Active Transport Response

Information Request Response

To	Kwikbridge Pty Ltd	Date	4 December 2023
Prepared by	Giada Rendina, Modus Graduate Traffic Engineer	Approved by	Tetteh Anang, Modus Senior Traffic Engineer (RPEQ 28656)
Location	81 Savage Street, Cooktown		
Subject	Proposed Shopping Centre Development - Traffic Engineering IR Response		
Status	Final	Attachments	Appendix A: Council Information Request Appendix B: Proposed Development Plans Appendix C: Existing Active Transport Network Appendix D: Pedestrian Crossing Facility Results Appendix E: Proposed Active Transport Network

project	2022-072	drawing no.	DA06	issue	TP3
scale @ A1	1:100	designed	MHa	checked	RRo

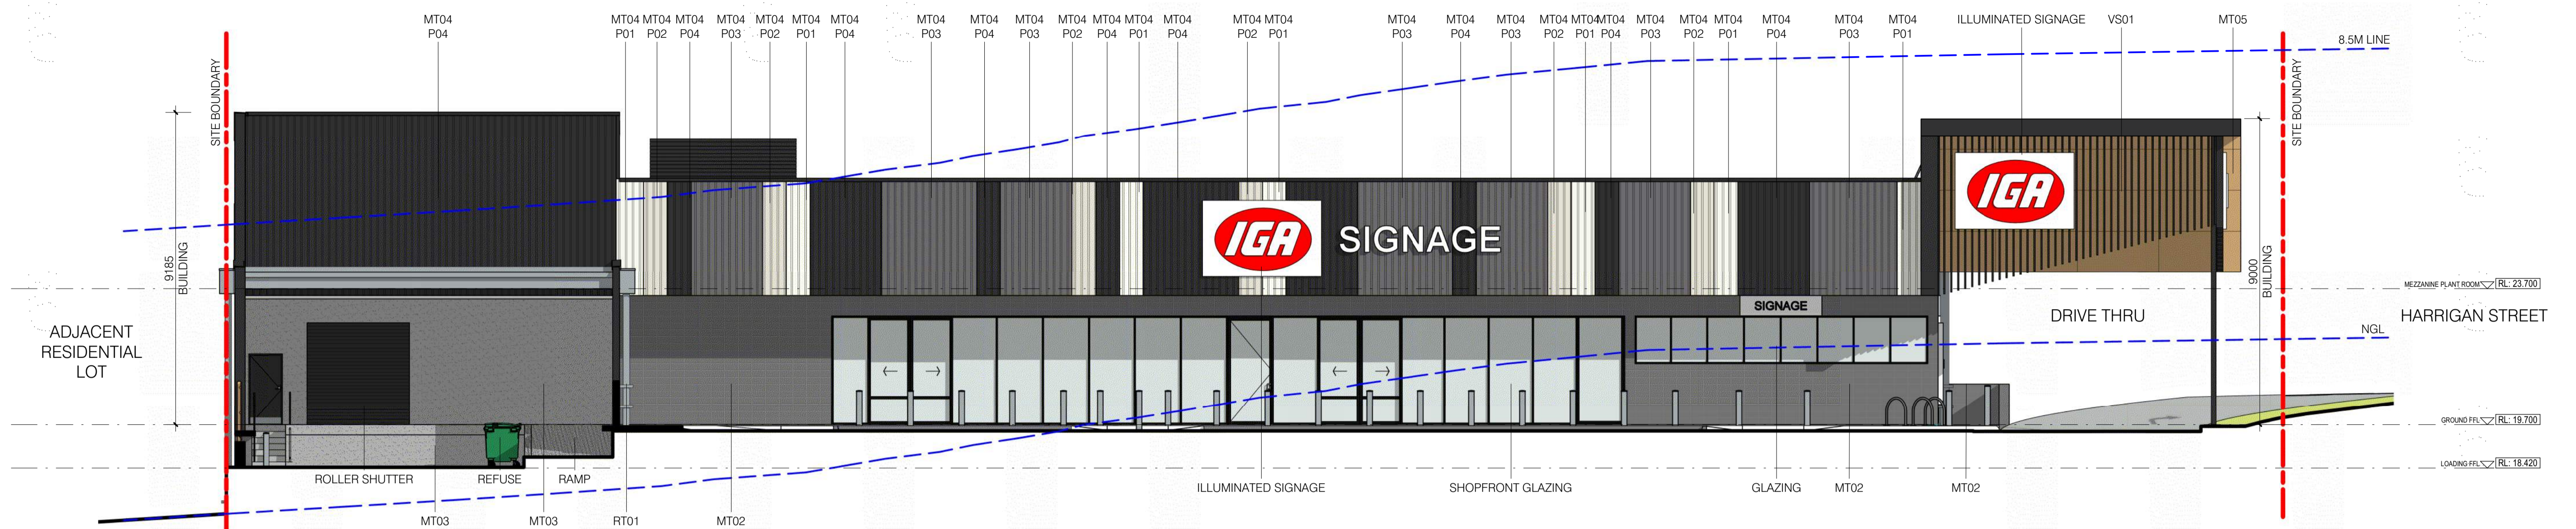
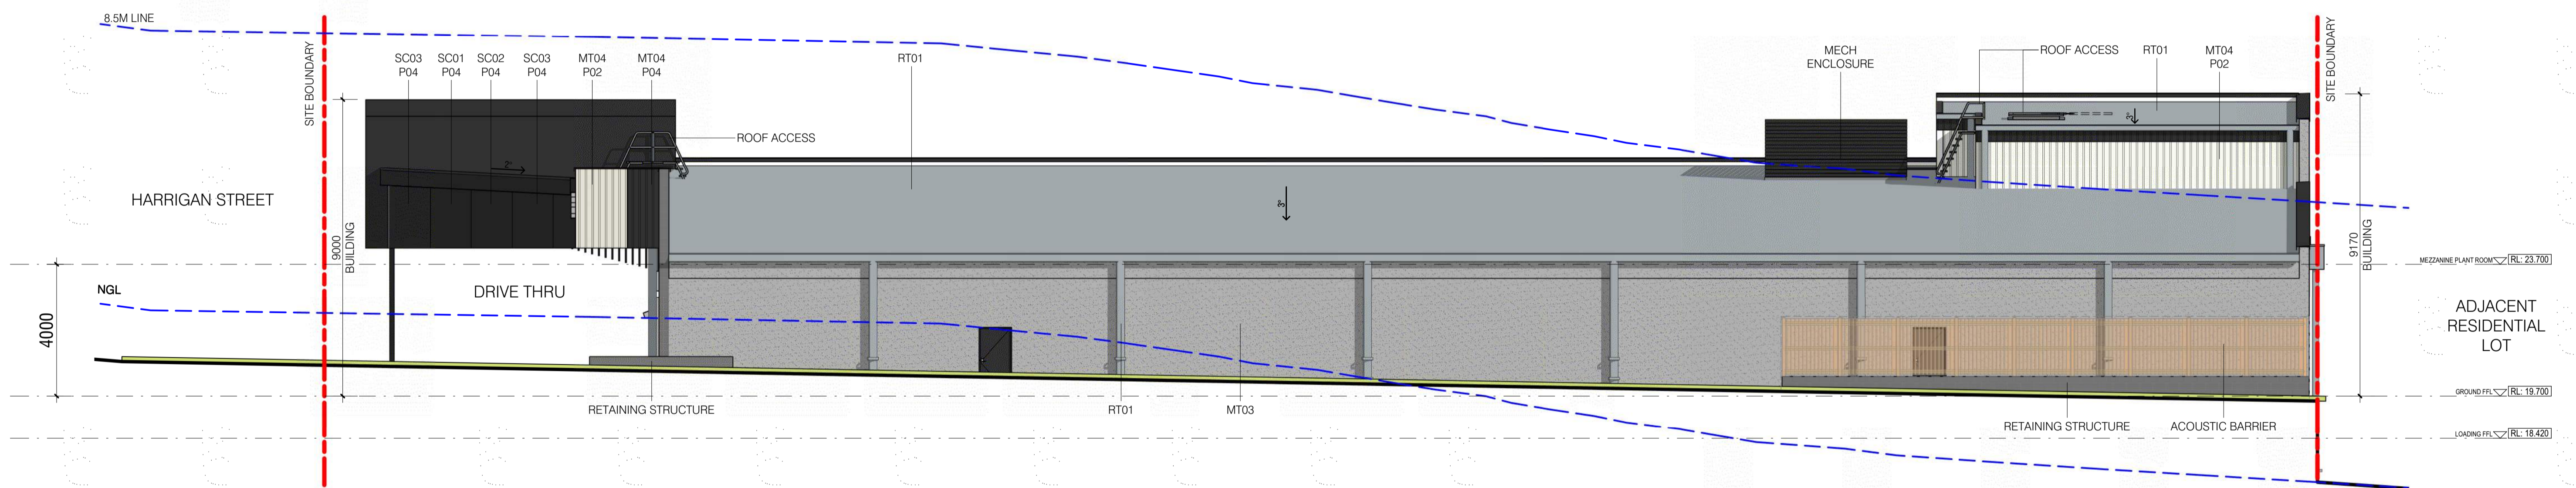
- 15. Provide revised drawings to eliminate the apparent encroachment across the Lot boundary as currently depicted in the Northern Elevation and Southern Elevation views shown on drawing DA06. All buildings and infrastructure must be located within the property boundary.**
